Re: Fire Station #5 Plan Review Conditions from 12/07/2022

Building Plan Review Reviewed By: Joe Frogge Rejected

Reference: Lee's Summit Fire Station 4 Storm Shelter Peer Review

11.21.2022

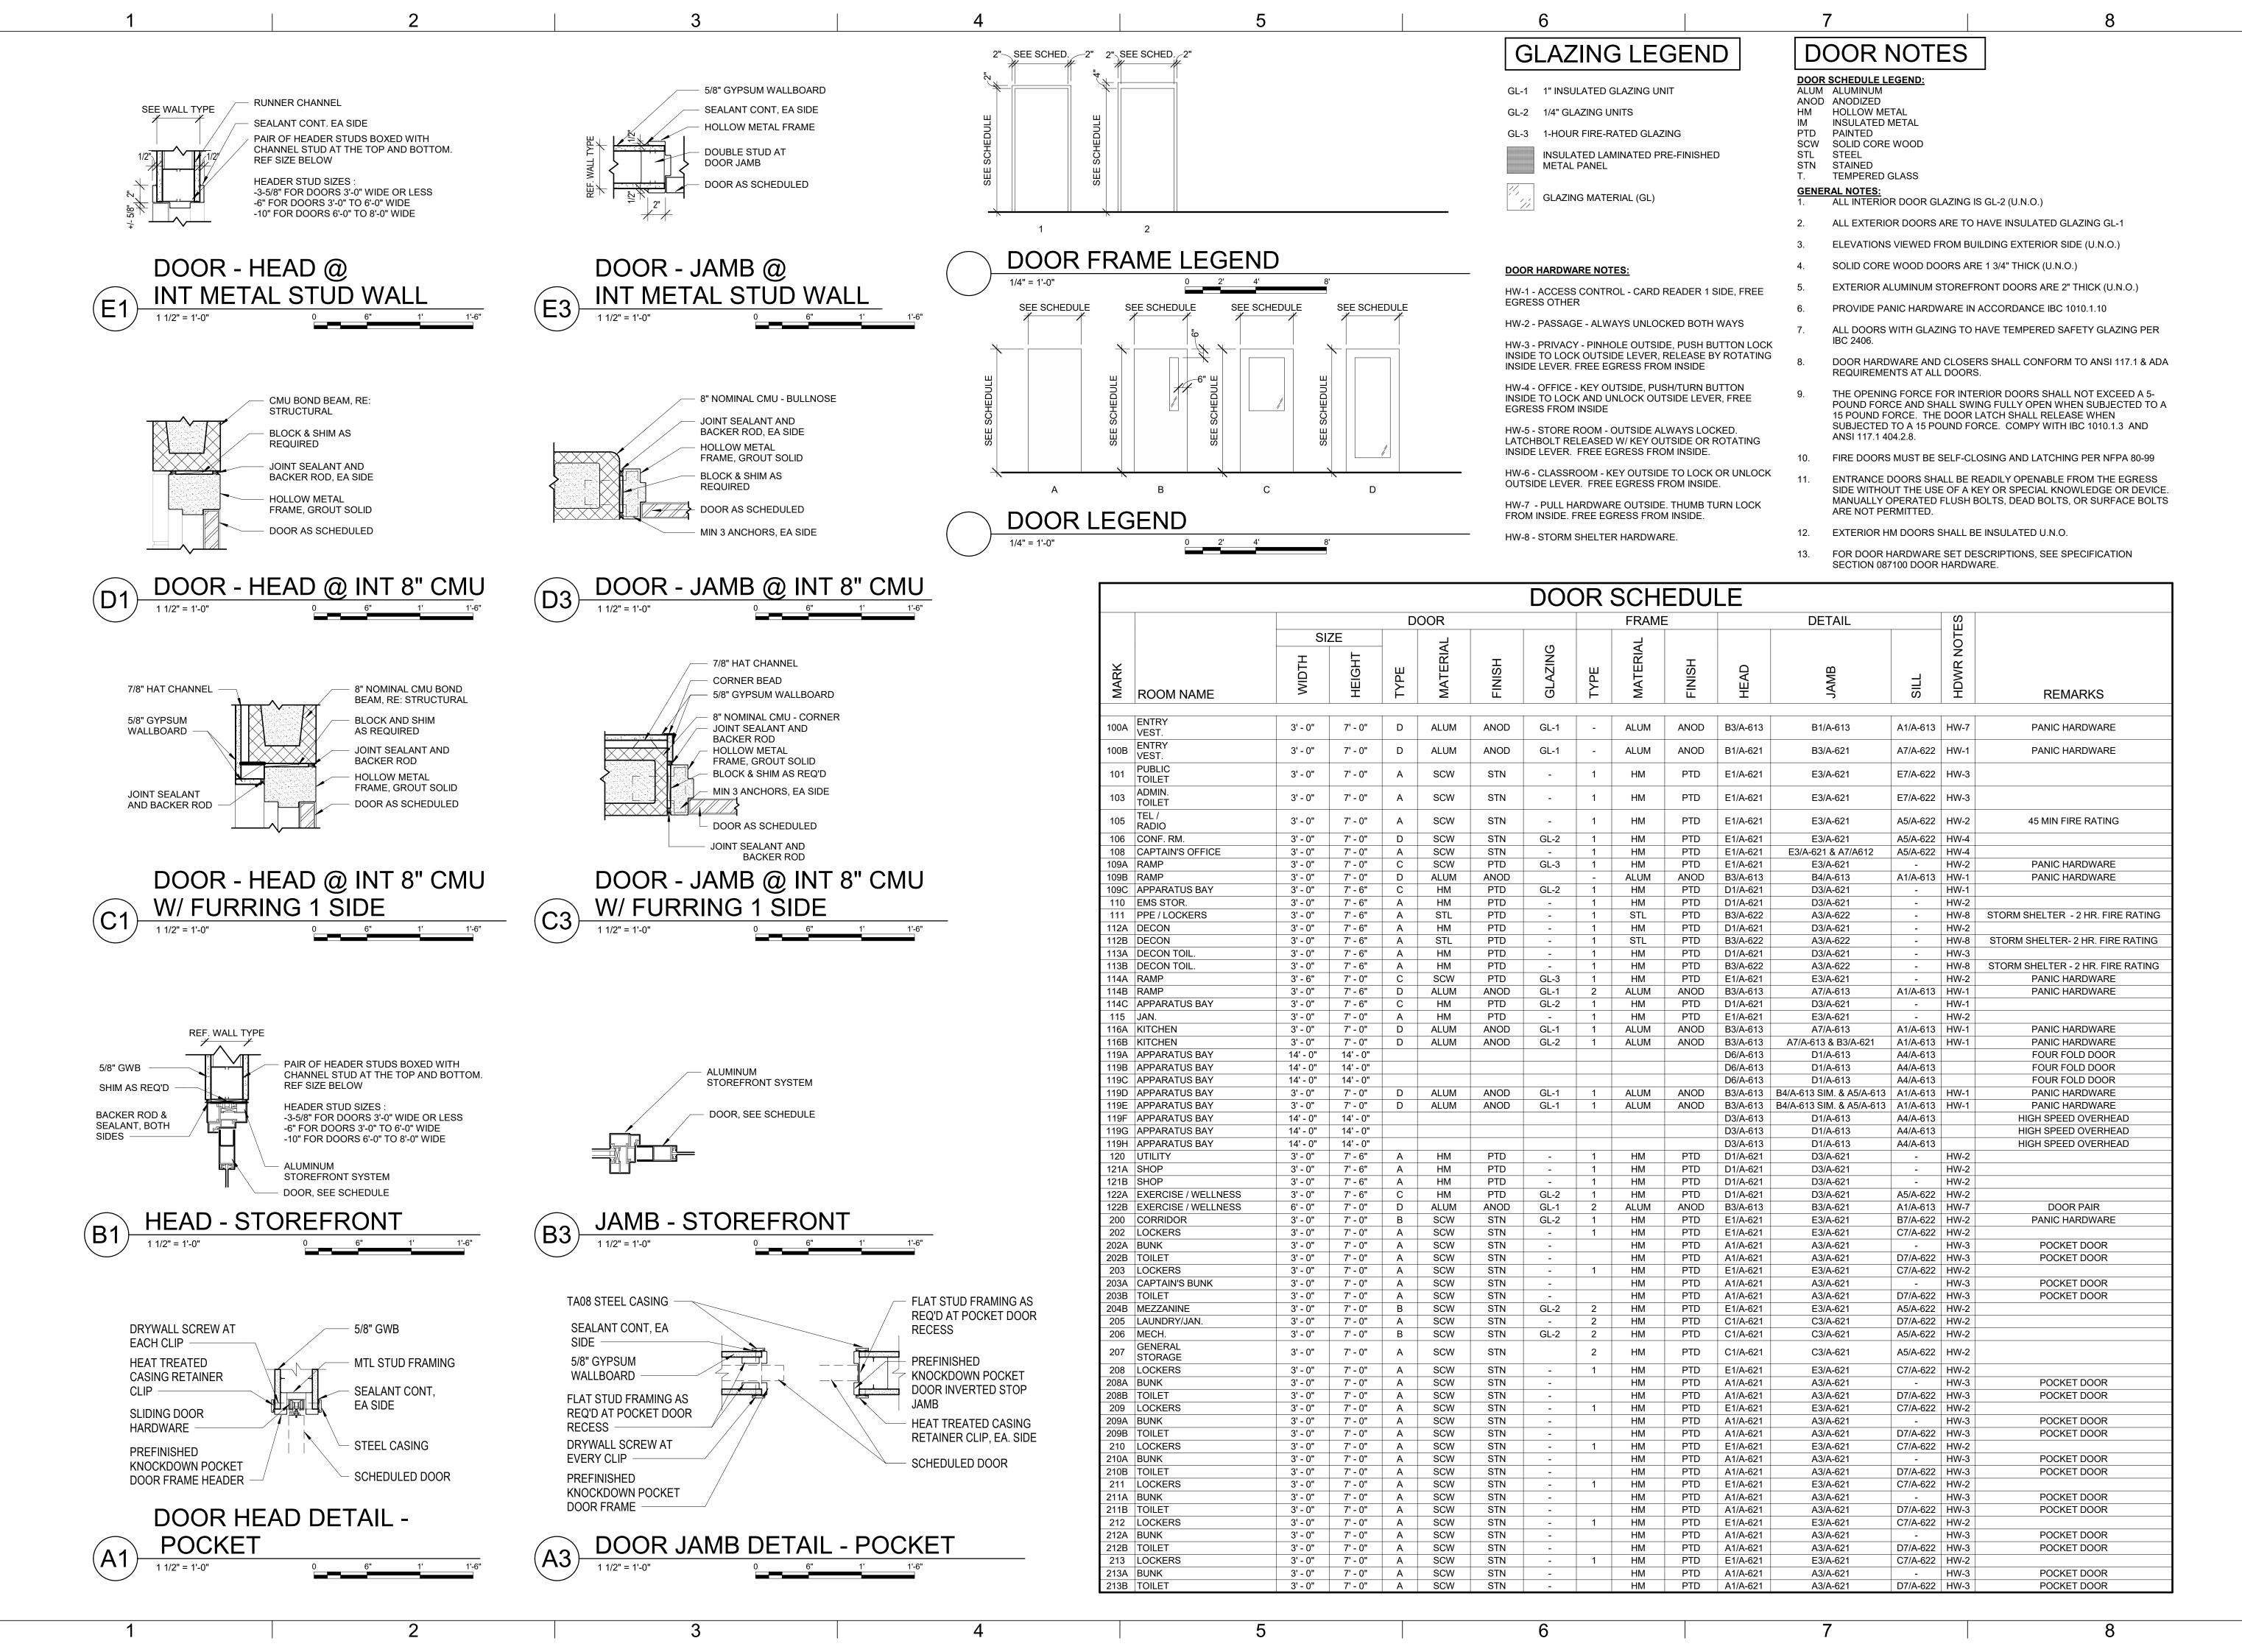
7. 2018 IBC 706.1 General. Fire walls shall be constructed in accordance with Section 706.2 through 706.11. The extent and location of such fire walls shall provide a complete separation. Where a fire wall also separates occupancies that are required to be separated by a fire barrier wall, the most restrictive requirements of each separation shall apply.

Action required: Provide complete UL details that include nail/screw patterns. 12/5/22 - Complete detail for UL 419 required

Responses: 12/23/2022 UL details, including fastener patterns for track, framing and sheathing are shown on sheet A-602 (see attached drawing sheet)
